RECEIPT DATE: 12/20/16 **ONSITE SEWAGE DISPOSAL SYSTEM** P 5-59883

PROPERTY ADDRESS: 13548 Mitchells Way W. Friendship, MD 21794

RE: 13548 Mitchells Way
West Friendship, MD 21794
"OSDS Plan"

I have reviewed the OSDS Plan for Cloverfield Sec. 1 Lot 8 and here are my comments.

SITE PLAN AND PLOT PLAN FOR BAT INSTALLATION
SPRING MILL LLC
13548 MITCHELLS WAY
TAX ACCOUNT NO.: 348830
LOT 8

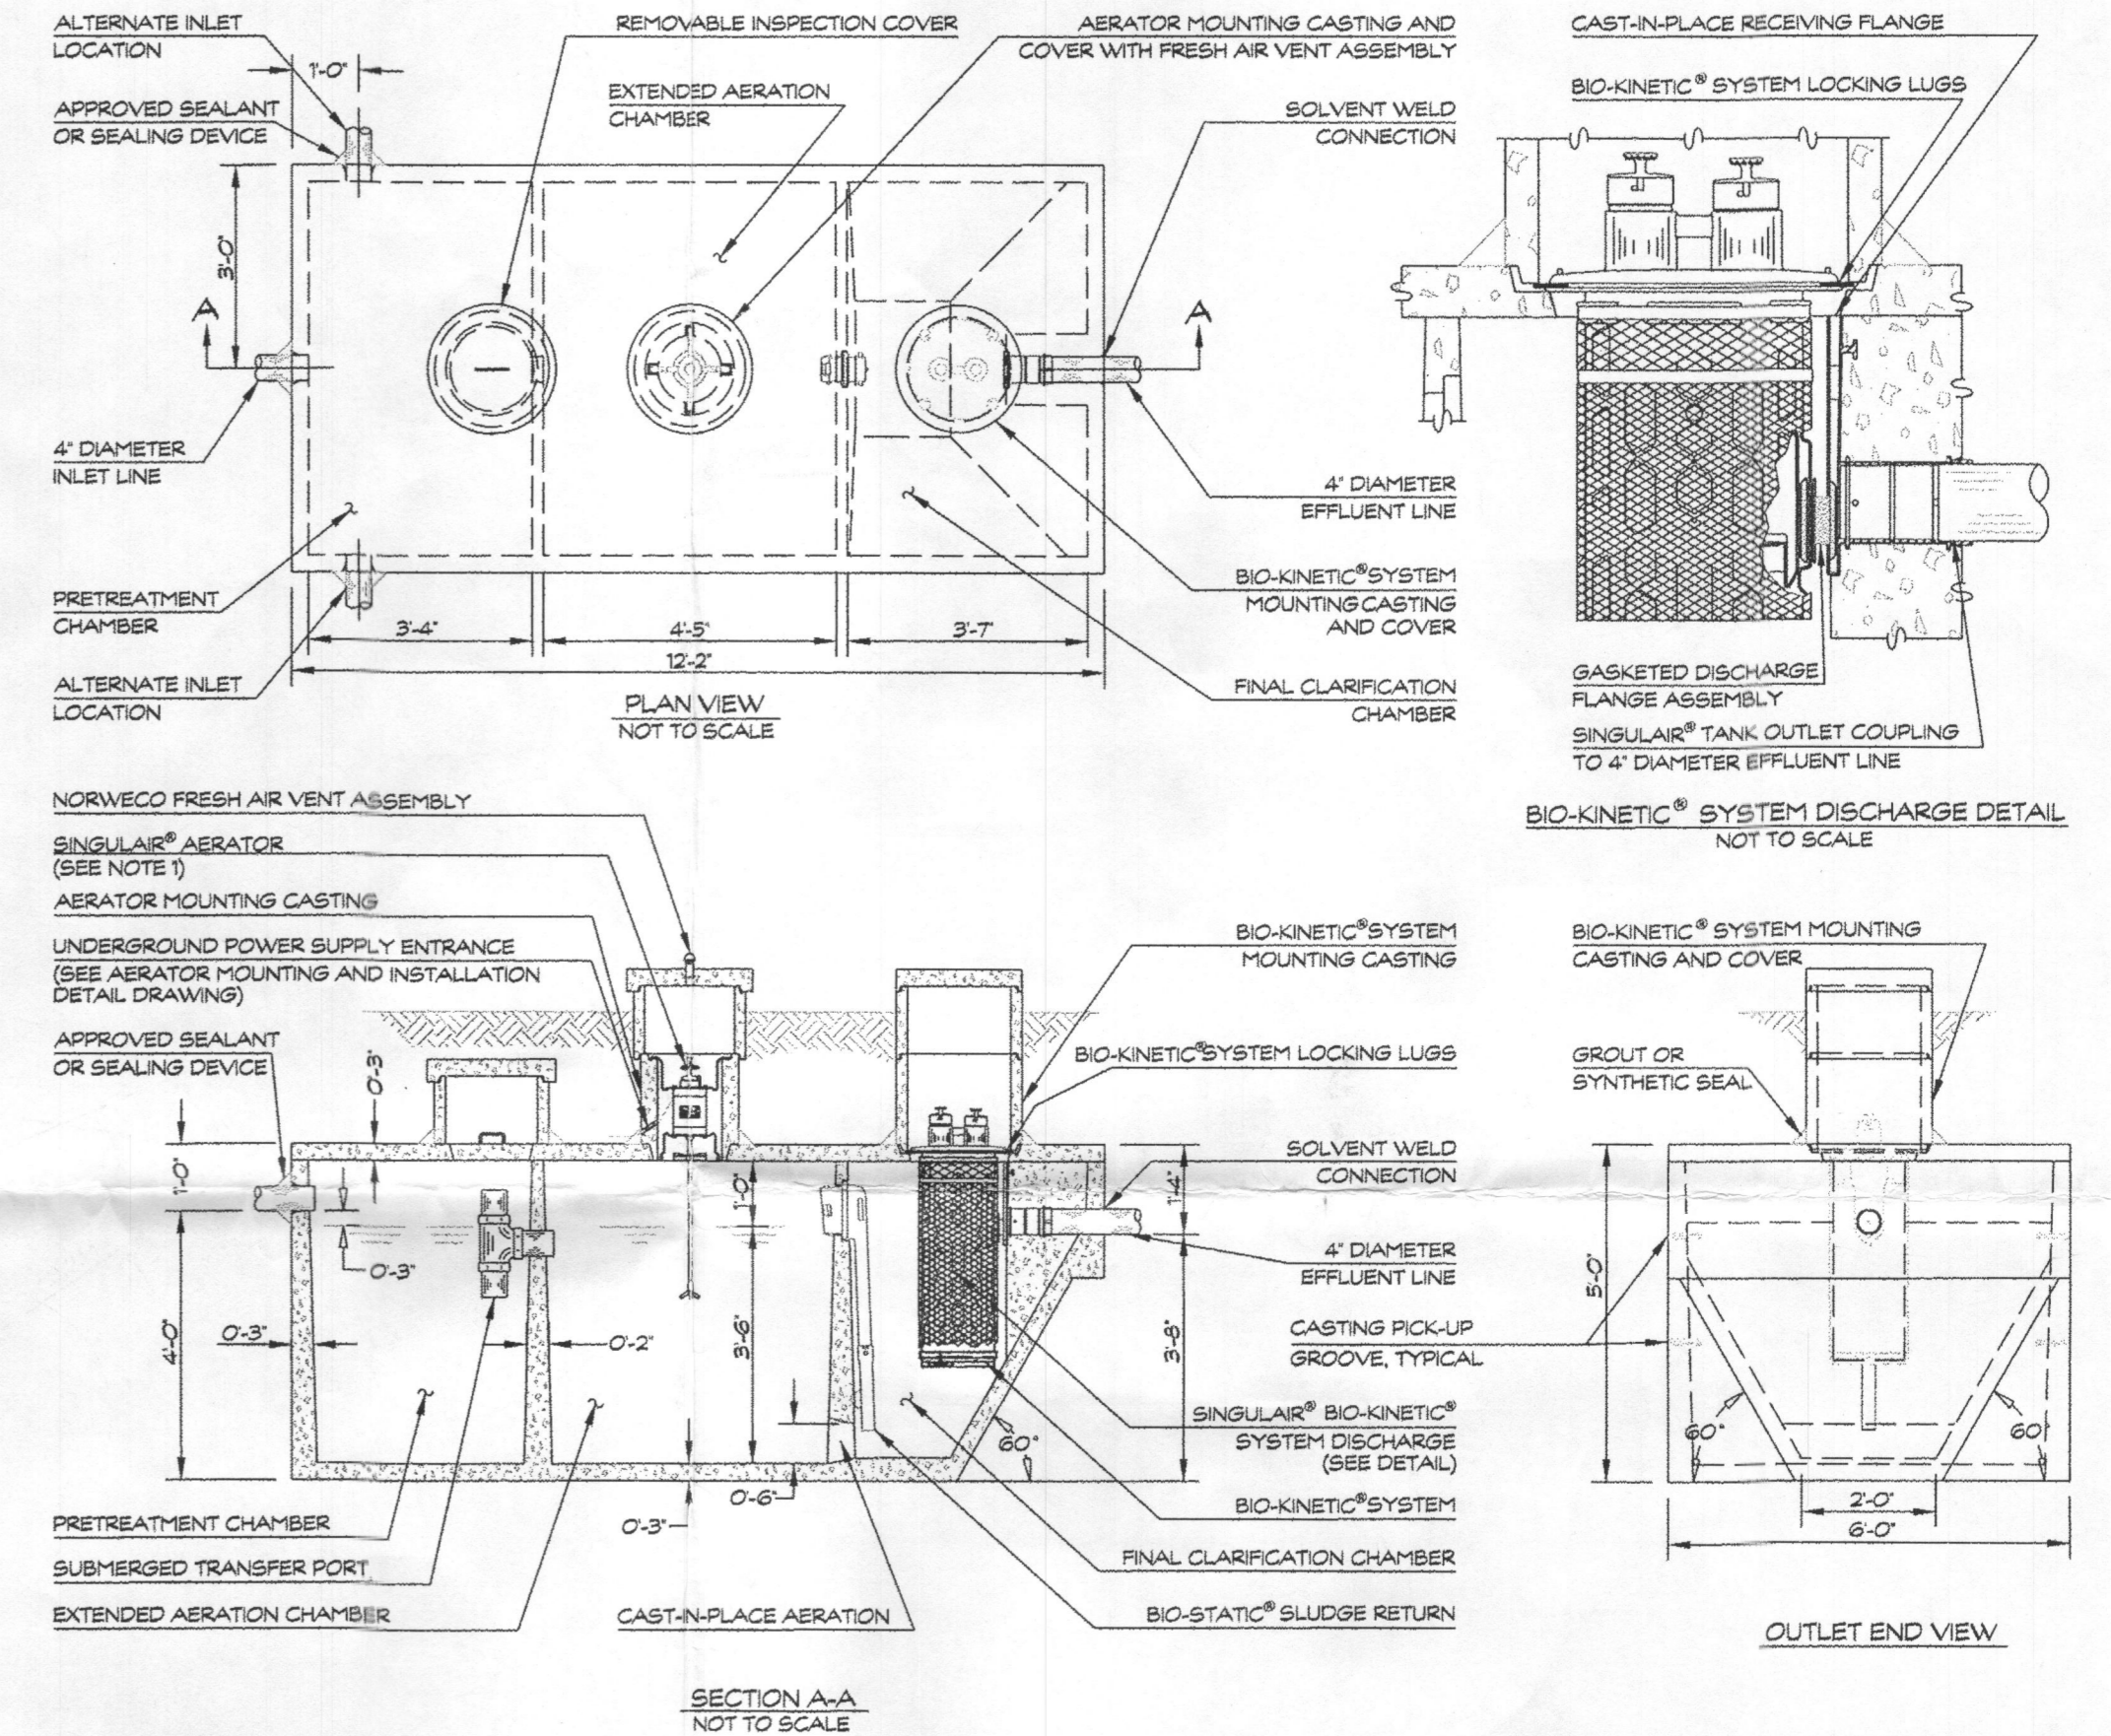
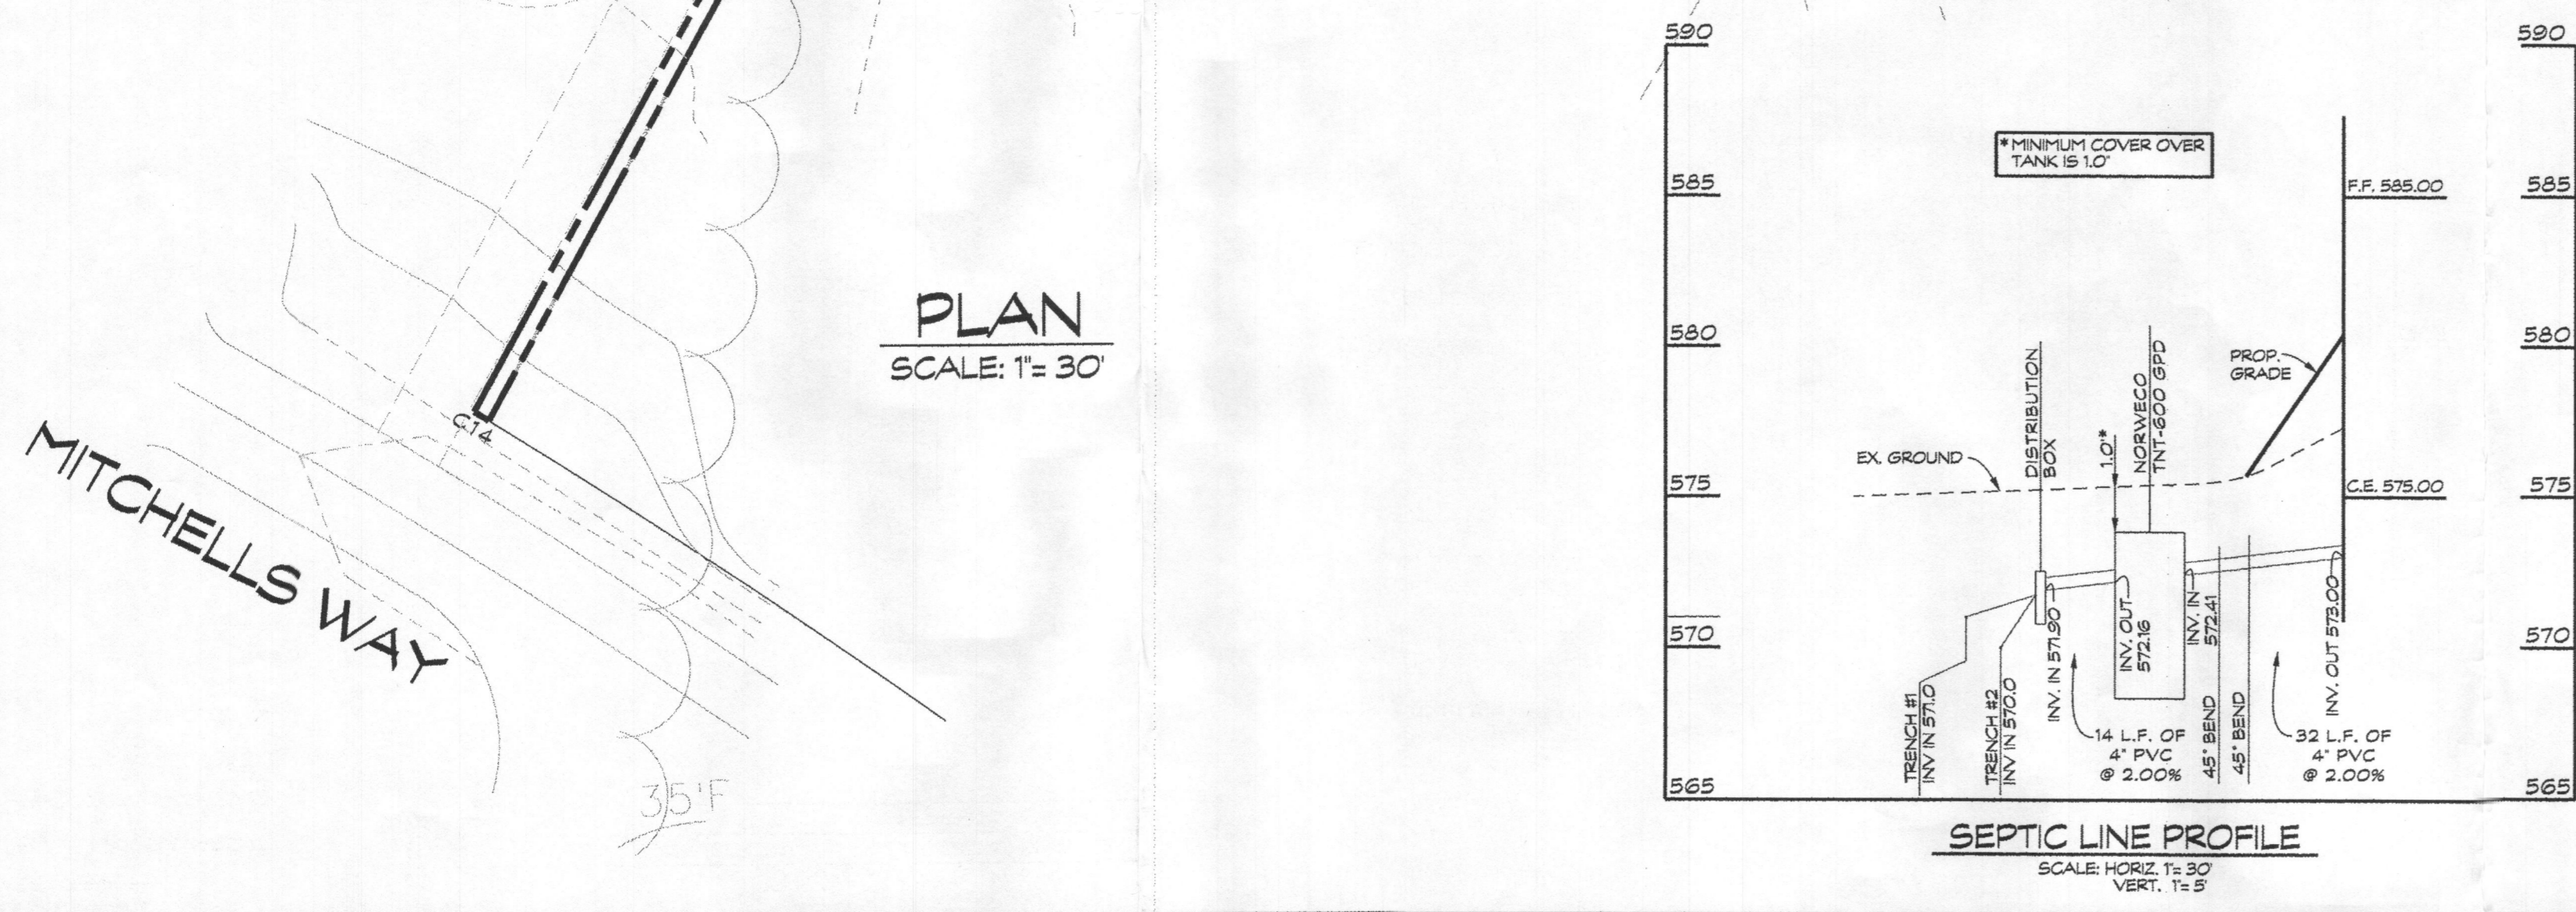
I am reviewing the building permit B16002792 for 13548 Mitchells Way. On the Site Plan & Plot Plan for BAT Installation Lot 8 the house needs to be at least 20ft from the SDA. We have a setback of 20ft between a new foundation and the SDA. The Septic Line Profile shows the inlet of the trench line to be 5 feet deep. Trenches are required to be no more than 4 feet deep as shown on the spec sheet. If you have any questions let me know.

Date	Revisions	Drawn By:
7/26/16	REVISED PER ROBERT FRESHMON EMAIL DATED 7/7/16	BM1
		Designed By:
		Reviewed By: LDA
		Date: 6/16/16
		Scale: AS SHOWN
		Job No.: 2013039
		Sheet: 1 OF 1
